Re: 1415 S. Arlington Heights Road

Listed below in **bold** are our responses to the comments received from various Village departments dated February 9, 2016 – February 18, 2016.

PLAN COMMISSION PC #16-003
Northwest Gastro
1415 S. Arlington Heights Rd.
PUD Amendment
Round 1

FIRE ENGINE TURNING TEMPLATE

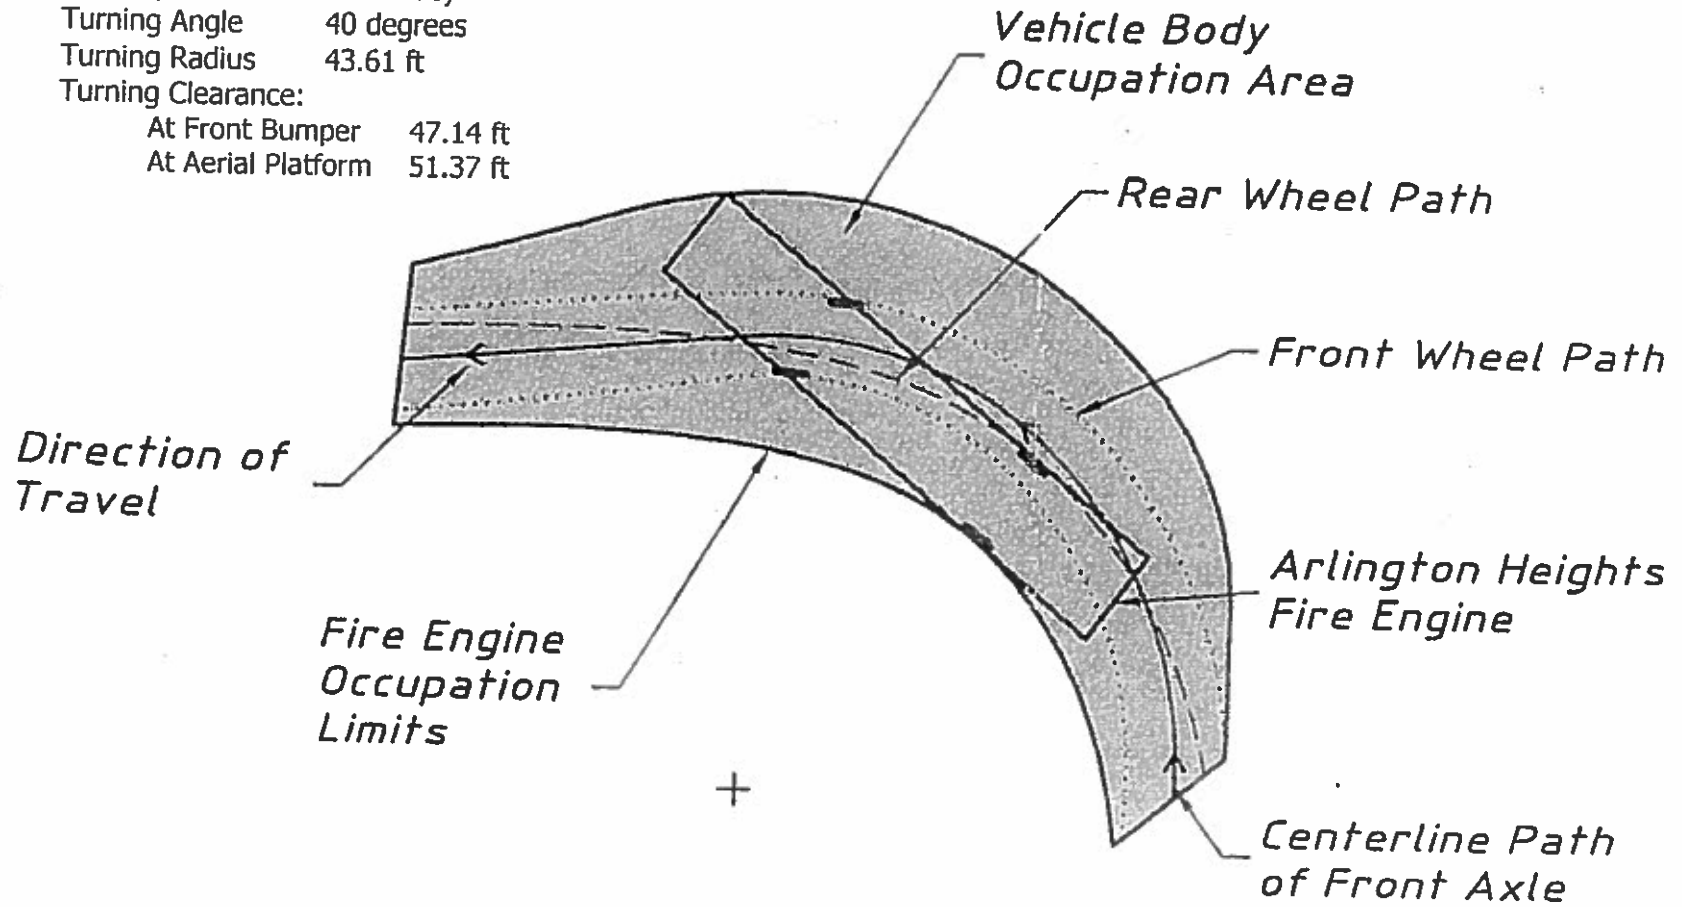
14. There are no changes shown to the existing parking lot lighting system.
15. Provide an exhibit to engineering scale showing the turning path of the Fire Department's responding vehicle, in this case the tower truck. Exhibit must show front and rear wheel paths and the extent of the front and rear overhangs, as provided in an "Autoturn" exhibit. The vehicle shall be shown maneuvering through the southeast corner of the site in both directions. Attached are the specifications for the tower apparatus.
